Village of Long Grove Illinois

MEMORANDUM

RE: July 6, 2016 - MEETING ISSUE REVIEW

1. **CSCC 16-02;** Consideration of the final plans for the subdivision of property to be known as the "Karen's Corner" PUD and within the R-2 Residential District, including the location of Conservancy District Boundaries & detention areas within Scenic Corridors and pathways on property commonly known as The Iverson Property at Old Hicks & Checker Roads submitted by Fidelity Wes Designers & Builders (Demar-Iverson Property).

PLAT OF SUBDIVISION
OF
KAREN'S CORNER OF LONG GROVE

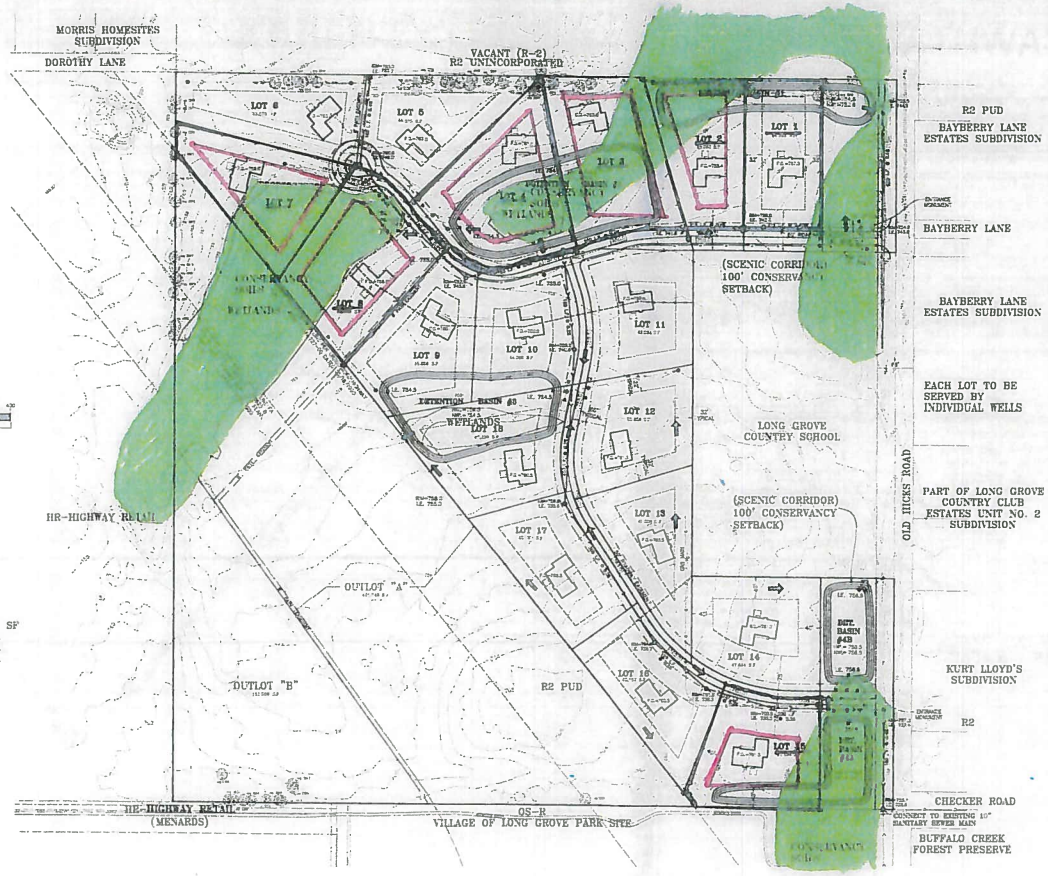
The attached final plat identifies some of the same boundaries for the conservancy and scenic corridor areas as was approved on preliminary plat however there are some differences. The conservancy soils which were identified in the potential right-of-way for the Route 53 extension are not shown. The conservancy soils in Outlot A (also a scenic corridor are not shown as well. The final plat also now identifies 17 lots instead of 18 as originally proposed.

- Consider any alterations to conservancy district boundaries as identified on the final plat in comparison to the preliminary plat to limit the potential for encroachment into the

easement while providing "logical" boundaries for the conservancy easement. The CSCC should discuss the changes to the final plat regarding the conservancy district boundaries. The CSCC has considered modification to conservancy boundaries in exchange for enhancements to the conservancy easement (in the form of native plantings), enhanced scenic corridors or possibly pathways and/or other site improvements **prior to platting.** The CSCC should review and approve the plantings proposed for the conservancy area (which also are stormwater detention areas) and the plantings in the scenic corridor.

TYPICAL 200' LANDSCAPE PLANTING

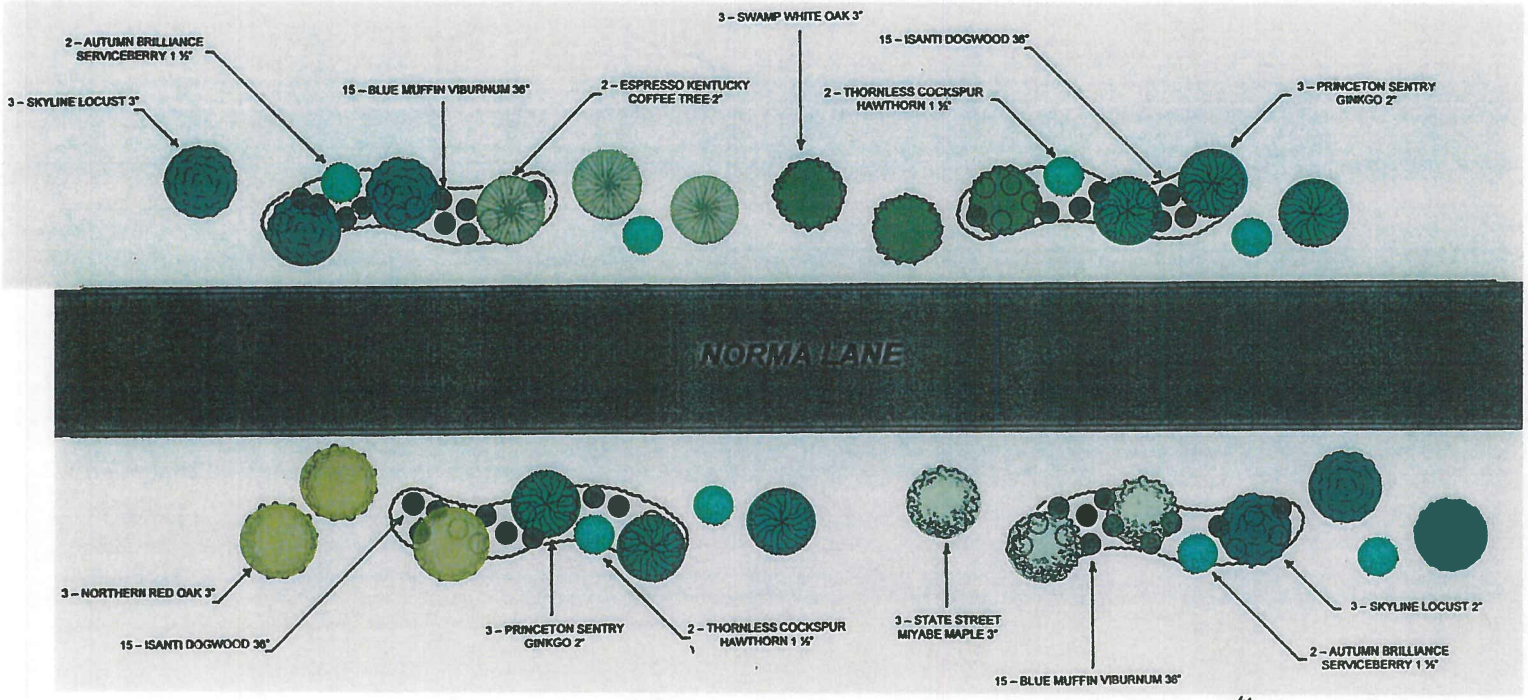
3. The typical 200' landscape planting detail by Dowden Landscape Design, dated 5-20-16, is acceptable, but I would recommend adding more space between the shade trees and making sure there are no site obstructions with intersections, driveways, light poles, street signs, hydrants, etc. There should be a minimum of 20' - 30' between shade trees and 15' - 20' between ornamentals/evergreens and no vegetation within 15' of driveways, intersections, light poles/signs, etc. I would not allow any shrubs to be installed within 5' of the curb/edge of road.

As noted in my initial landscape plan review dated 3-21-16, I would not recommend planting multi-stemmed trees, such as river birch, in the parkway as the sightlines may be obstructed with such trees.

If the spacing that I have proposed will not allow the quantities to be installed along the parkway, I would recommend allowing these plantings to be installed in open space areas within the project or within the lots themselves, outside of utility easements and construction envelopes.

KAREN'S CORNER OF LONG GROVE – PATHWAYS

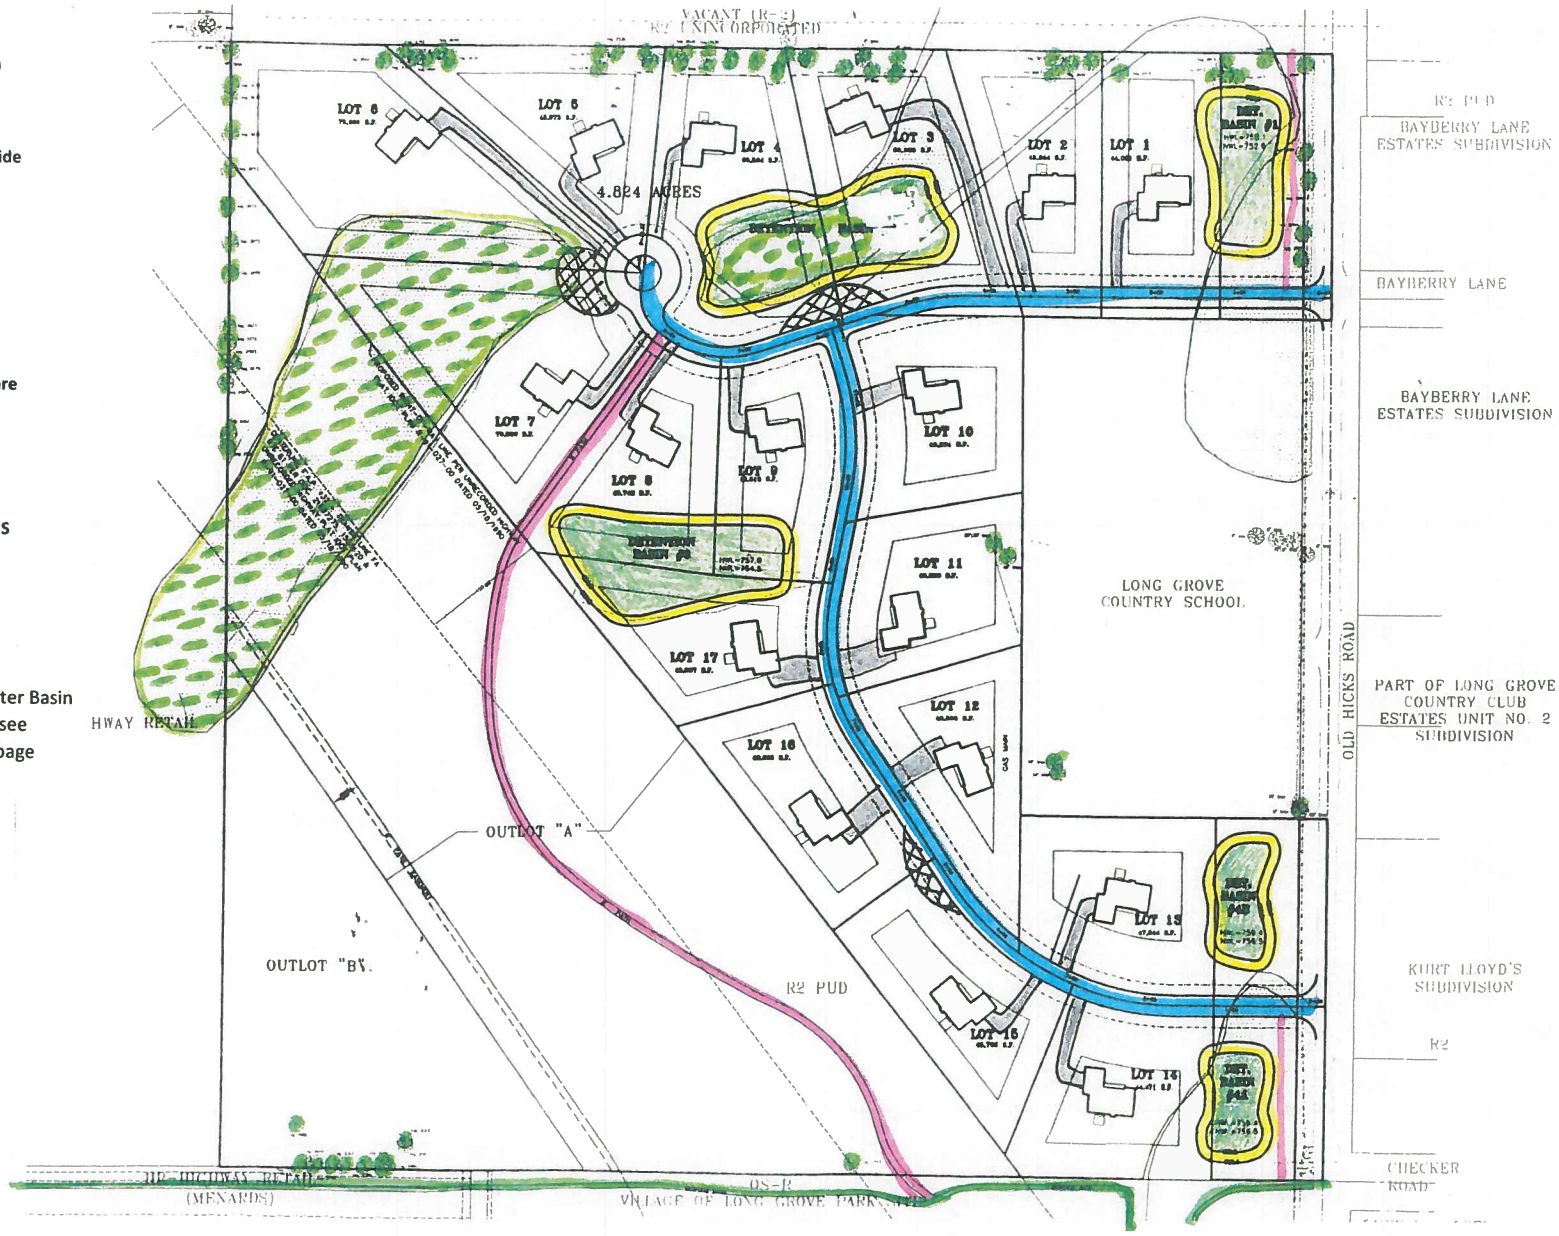
As proposed the petitioner has identified an 8" pathway easement in a slightly different configuration than preliminarily shown. This was anticipated and consistent with the preliminary recommendation of the CSCC. Pathways will loop (partially using internal roadways) and connect to adjacent pathways to the south. The pathway configuration was reviewed and accepted as proposed by the Pathways Committee on 6.13.16.

- Pathways will loop (partially using internal roadways) and connect to adjacent pathways to the south. The pathway configuration was reviewed and accepted as proposed by the Pathways Committee on 6.13.16. The CSCC may consider concurrence with recommendation and accept the pathways as proposed.

KAREN'S CORNER OF LONG GROVE – LANDSCAPE PLAN – BERM

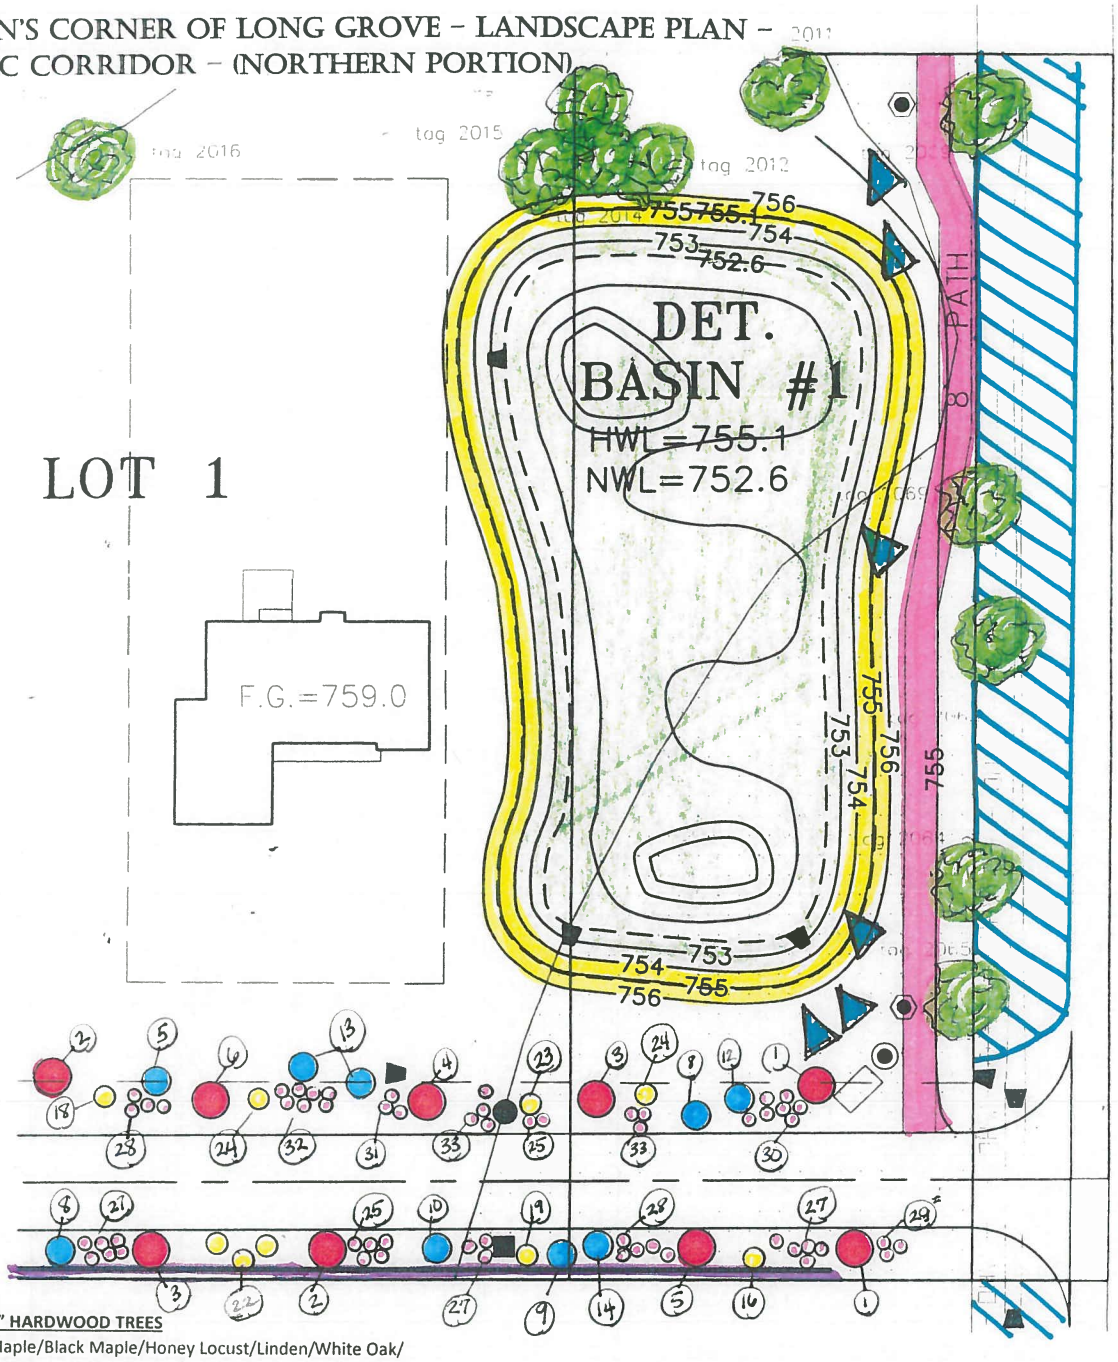
2. None of the trees proposed to be removed for the berm in the southwest corner of the site are protected trees. They are primarily cottonwood with boxelder maple, black locust, mulberry, black willow and other species typically found in low, poorly drained sites. The developer is planning on constructing this berm prior to the other infrastructure construction. As long as the Village engineer does not have any issues with this, I don't have an issue with this.
